## SERVICE BULLETIN

**APPLICABILITY:** 2019-24MY Ascent  
2019-24MY Forester

**NUMBER:** 12-265-25

**SUBJECT:** Power Rear Gate Drive Unit Design Change

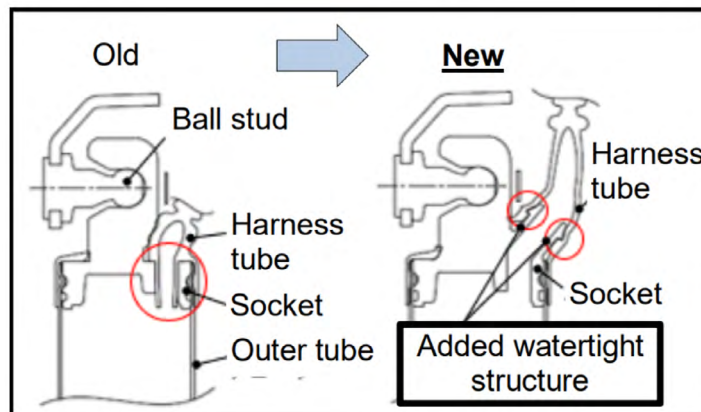
This bulletin announces design changes made to the Power Rear Gate Drive (PRG) Unit to address concerns of the power rear gate being inoperative. Customers may report various concerns with the PRG operation such as beeping without operation, erratic gate functionality, and incorrect stopping points. The shape of the harness tube and socket joint has been changed to enhance the water sealing performance eliminating corrosion buildup inside the unit.
